# Request for Information

**Project:** Ocean Discovery  
**Title:** Solar Scope Clarification  
**From:** Soltek Pacific  
**To:** Rob Wellington Quigley  
**Plan Ref:**

**Document:** **No. 0206**  
**Sub Ref. No.:**  
**Date:** 10/26/2016  
**Required Date:** 11/02/2016  
**Response Date:**

PROJECT NO.	R.S.	A.P.
FILE NAME		
DATE	06/11/2015	DRAWN CHECKED PJC
REVISIONS	SHEET NO. <b>E5.7</b> OF - SHEETS

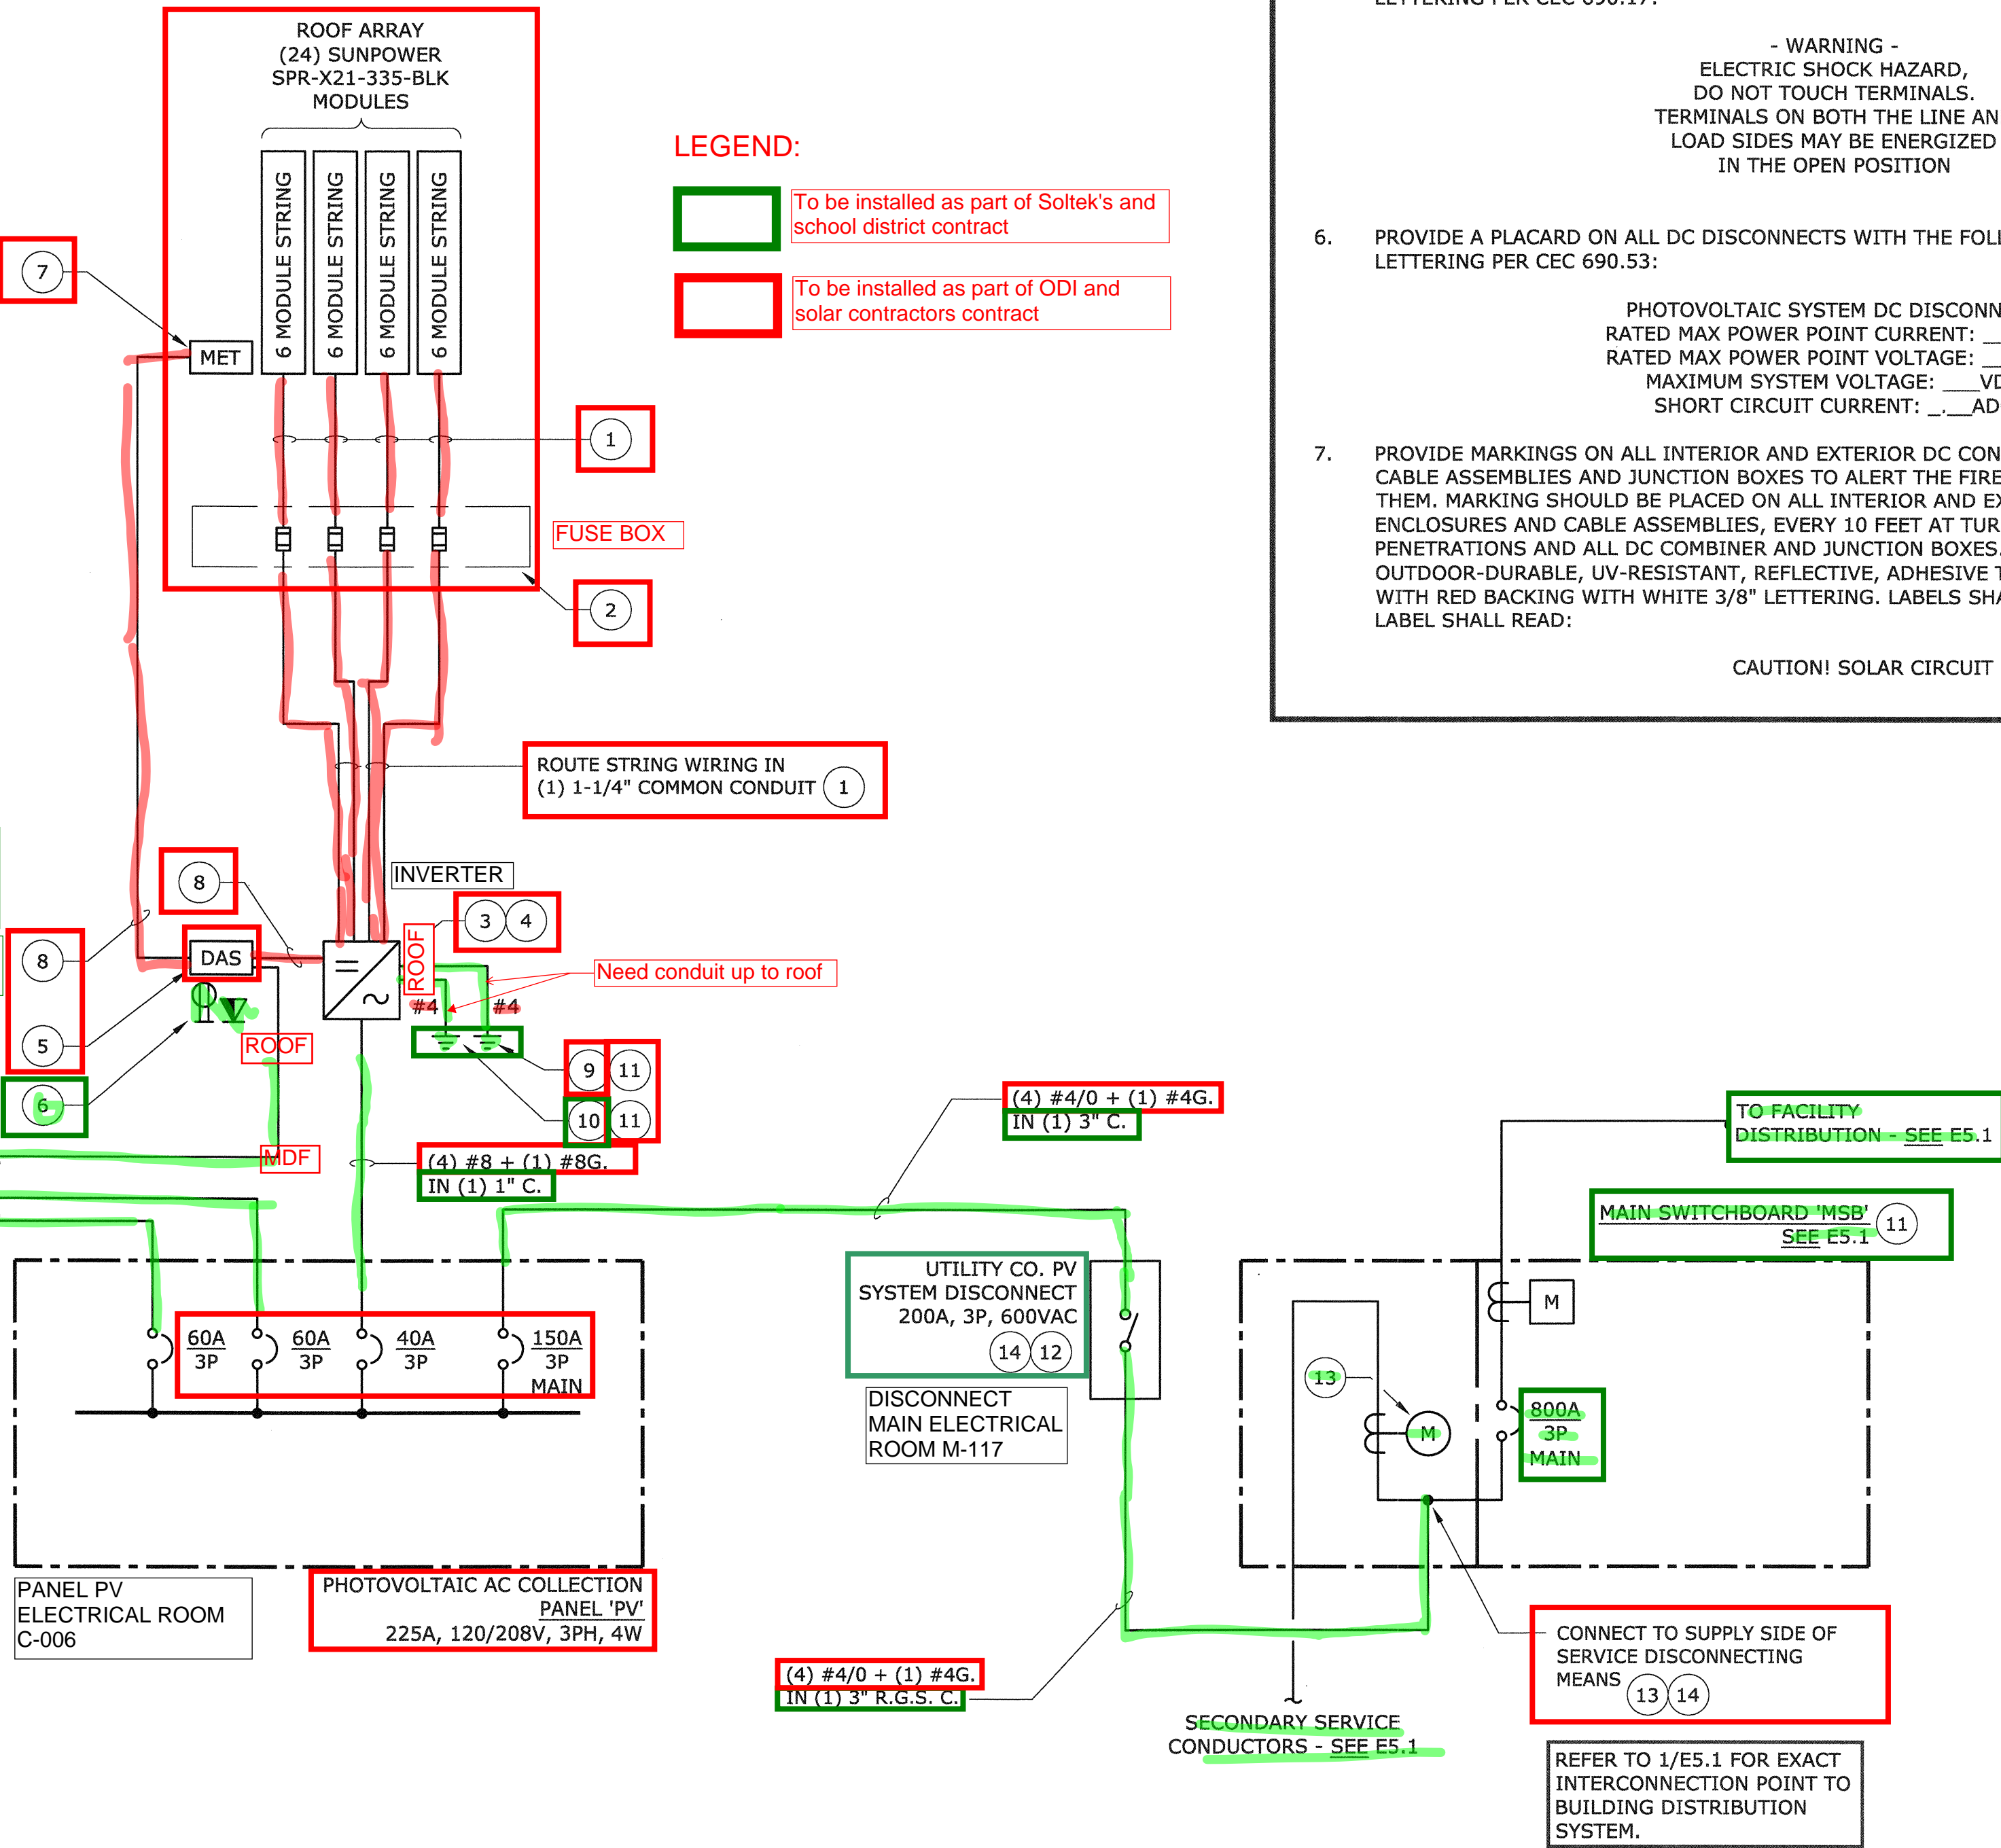
- Procurement and installation of the grounding of inverter(s) Note 9, 10 and 11 on Sheet E5.7
- Procurement and installation of the DAS, note 5 on Sheet E5.7

- Procurement and installation of the raceway and wiring from the inverter to the DAS, note 8 on Sheet E5.7
- Procurement and installation of the MET, note 7 on Sheet E5.7

- Procurement of installation of string wiring from the inverter to the fuse box, Note 1 on Sheet E5.7
- Procurement and installation of the fuse box, note 2 on Sheet E5.7

- Procurement and installation of the conduit and wiring from the fuse box to the module strings, note 1 on sheet E5.7
- Procurement and installation of the roof arrays (24) Sunpower SPR-X21-335-BLK Modules.

- Procurement and installation for any conduit and wiring for power or communications to the solar trees. Addendum #4 labeled the solar trees as future (Addendum #4 A2) and no Envision drawings were ever provided (referencing Sheet E5.7) calling out for conduit size or wire size. Any reference to specific manufacturer was also disregarded (Addendum #4 A31) making it impossible for PAR to bid.

- To be installed as part of Soltek's and school district contract
- To be installed as part of ODI and solar contractors contract
